PRODUCT/PROCESS CHANGE NOTICE (PCN)

PCN #: **G-0206-08** DATE: 6/17/2002
Product Affected: All square PQFP and TQFP packages
shipped in Tape and Reel

ATTACHMENT - PCN #: G-0206-08

FROM:

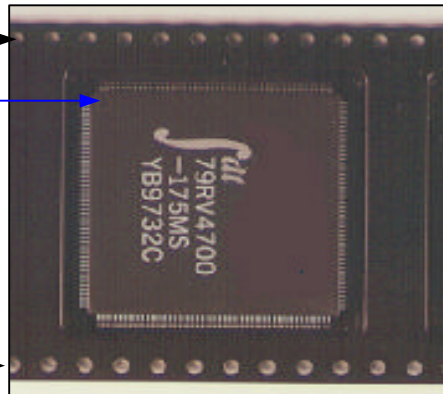
Detail of Change: This change will be implemented on all square PQFP and TQFP packages.

Electrical Pin# 1 and Dimple

TO:

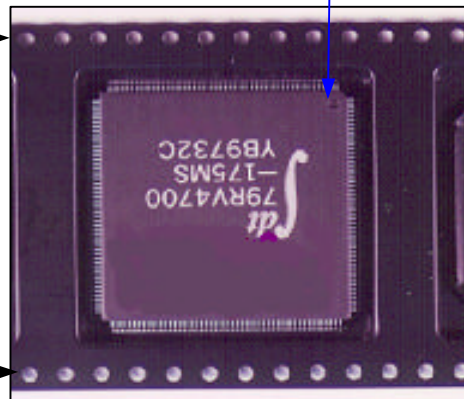
Electrical Pin# 1 and Dimple

PCN Type: To comply to current EIA Standards (EIA-481-2-A) requirement.

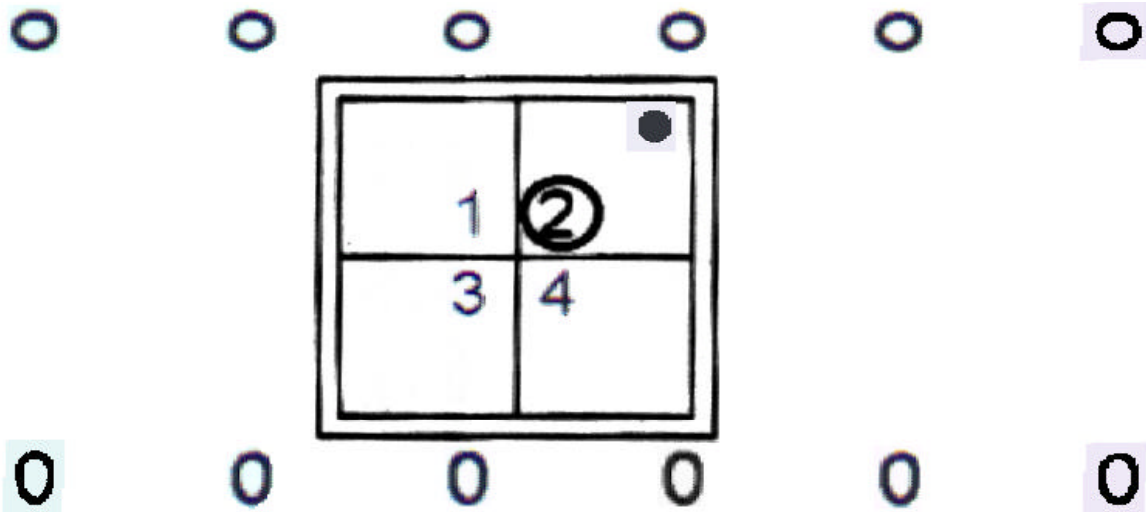
Additional label will be placed on the intermediate box (pizza box) to alert customer of this change.
Label will be placed starting (ww38) 9/17/2002 until 9/17/2003.
